**ITEM 9.1.3  
APPENDIX 3**

### DA ASSESSMENT REPORT

DA No. P940

Proposal: Showroom

SITE PLAN

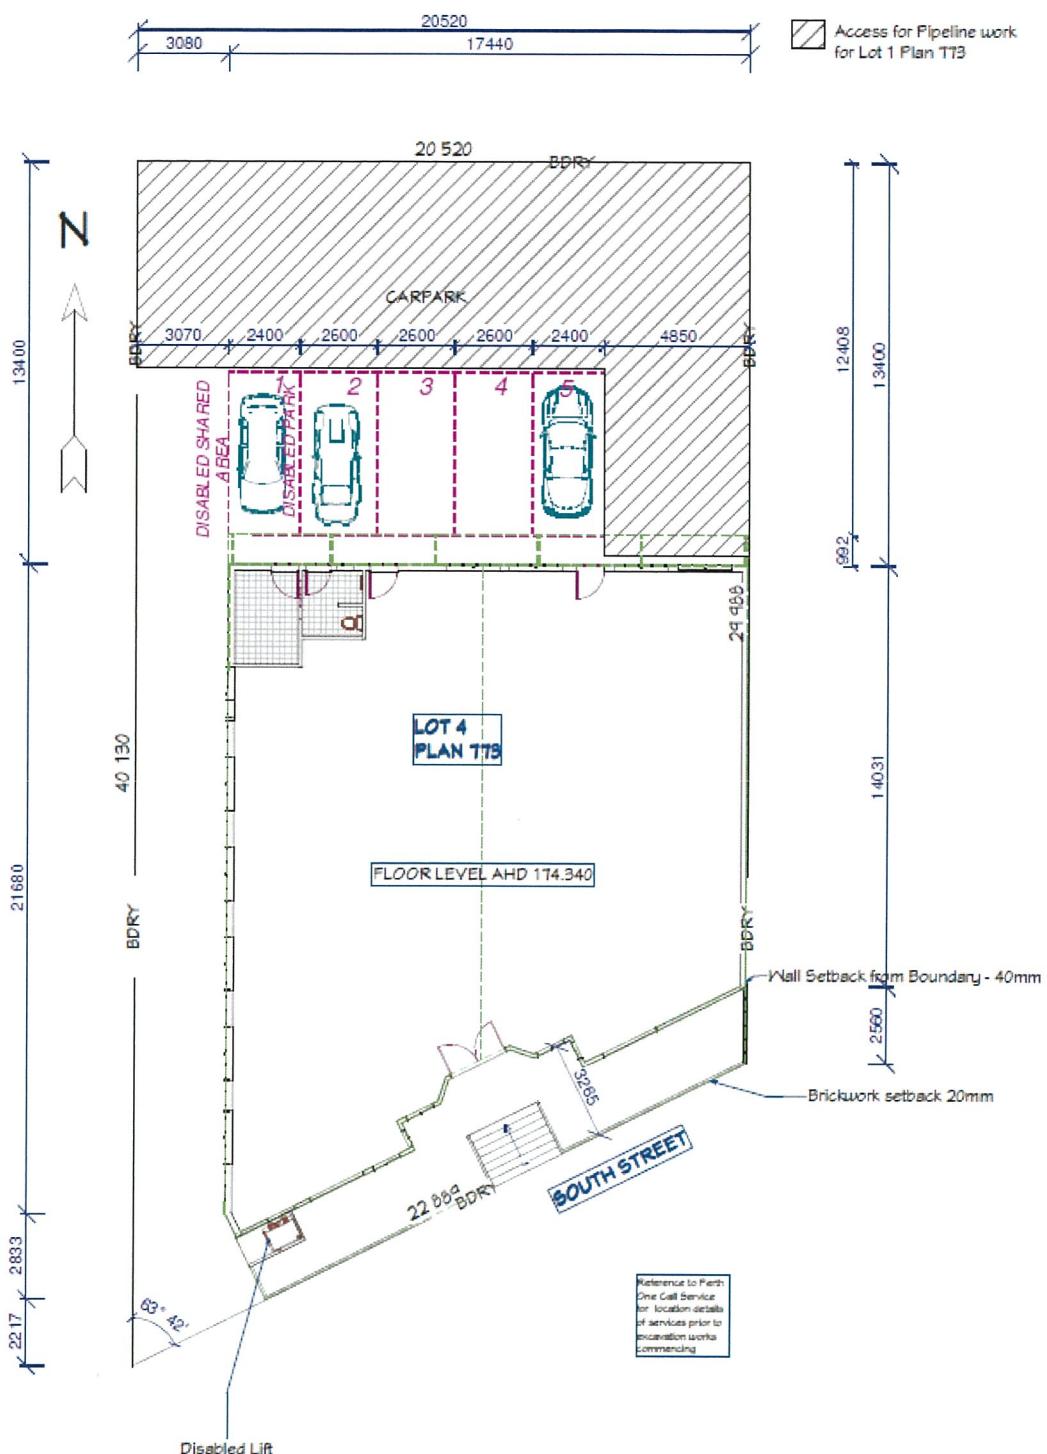
8.	22 May 2015	Allan Rourke, Works Manager	n/a	<ul style="list-style-type: none"> <li>With regards to the parking requirements it looks ok though the shared disabled bay seems to be included in the main access which will cause problems, and with the vehicle access lane there needs to be some thought into managing the traffic movement from a safety point of view with not being able to see if vehicles are entering or leaving the property.</li> </ul>	<p>Noted.</p> <p>Revised site plan required as condition of approval.</p>

- e) *the locations of proposed public footpaths, vehicular crossing, or private footpaths within the lot, and the effect on both pedestrian and vehicular traffic movement and safety;*  
A revised site plan is required to detail the accessway from the car parking provided to the entry/entries of the building i.e. front and rear.

The parking area has a driveway that accesses South Street. Adjoining this property on the western boundary is an easement used by the western neighbouring properties however this particular property does not have benefit to this. The proposed accessway is suitable to service the lot however further detail is required regarding the access for disabled persons.

The application proposed 5 spaces, and is considered compliant with this requirement. Further assessment of this will be required as per the amended site plan to be submitted with regard to pedestrian access and disabled provisions.

**ELEVATIONS**

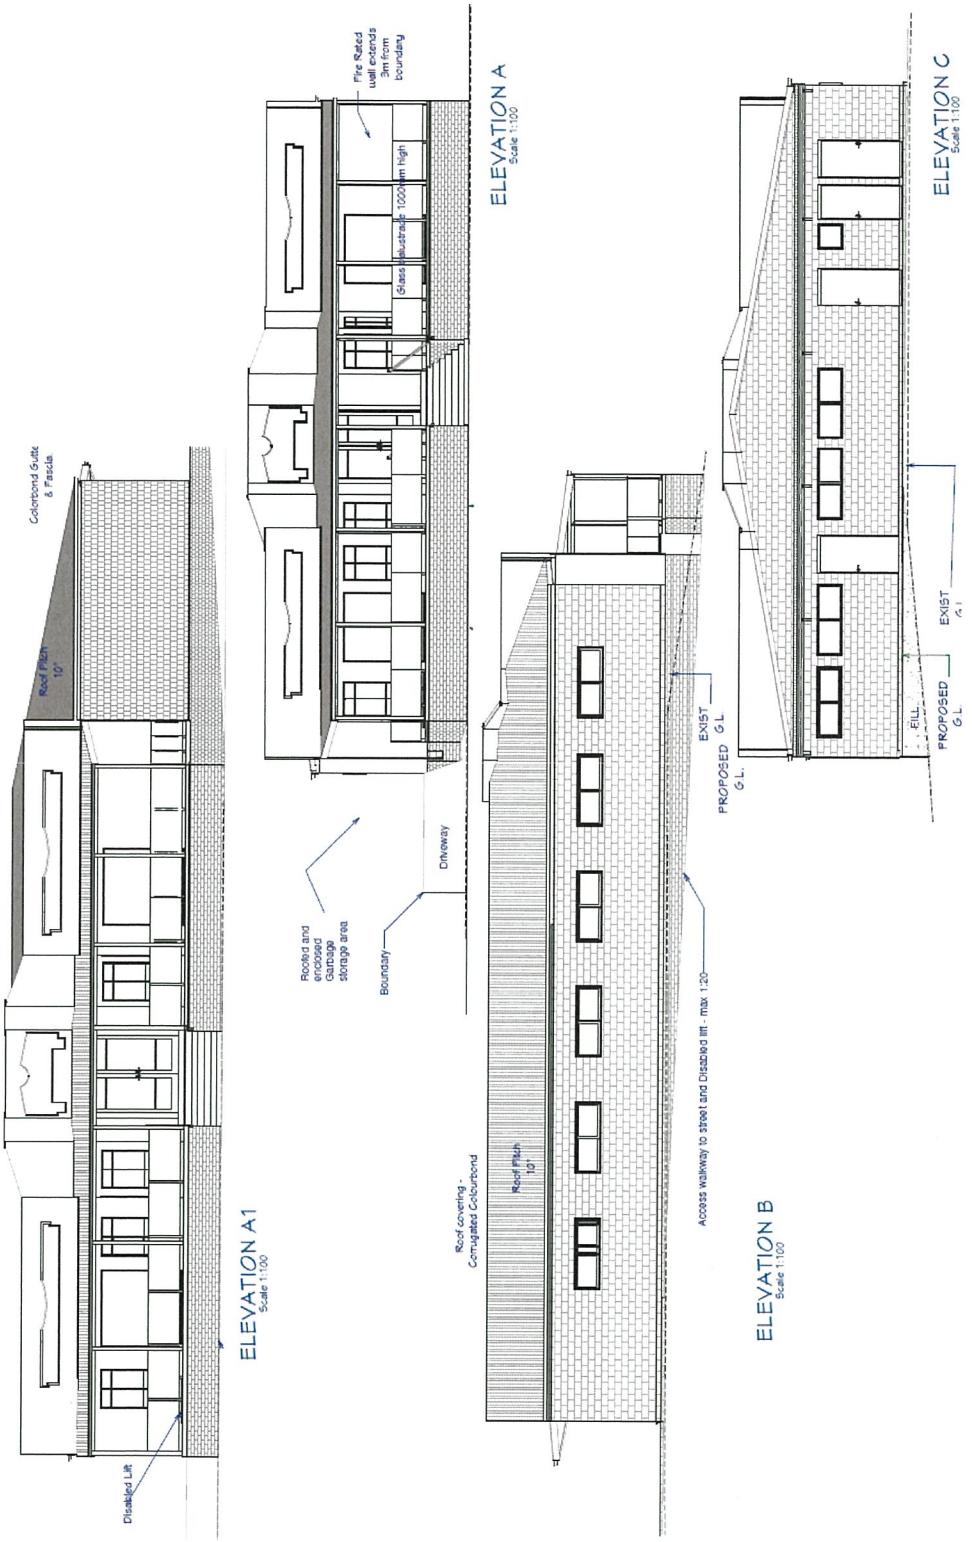
7.	20 May 2015	The York Society	n/a	<ul style="list-style-type: none"> <li>That the Materials and colours reflect the conditions of the heritage policy for that area and fit with the surrounding buildings.</li> <li>That the down posts be made of wood</li> <li>That the south wall could be a feature using local materials e.g. rock</li> <li>Traffic – if the turn around is difficult for trucks unloading rather than reverse into South Street, which in itself would be dangerous; they may well choose to unload in Avon Terrace in front of businesses they are delivering to. This is not good for the tourists' view of Avon Terrace.</li> </ul>	<p>Noted.</p> <p>Submission of a final schedule of colours and materials has been conditioned.</p> <p>Access has been considered in this assessment.</p>

<p>note;</p> <ul style="list-style-type: none"> <li>• The rear carparking configuration has altered- no effect on heritage issues.</li> <li>• The verandah width at the lift location has been amended- no effect on heritage issues.</li> <li>• The glass balustrade note has been added.</li> <li>• Overall, with reference to the plans as submitted, and the relevant policies, there seems minimal amendment with regard to heritage issues, and as previously stated, I support the proposal and complement the Owner on his consideration of the issues and the well resolved outcome.</li> </ul>

As a condition of approval, a final schedule of colours and materials is to be submitted to and approved by the local government prior to the commencement of works.
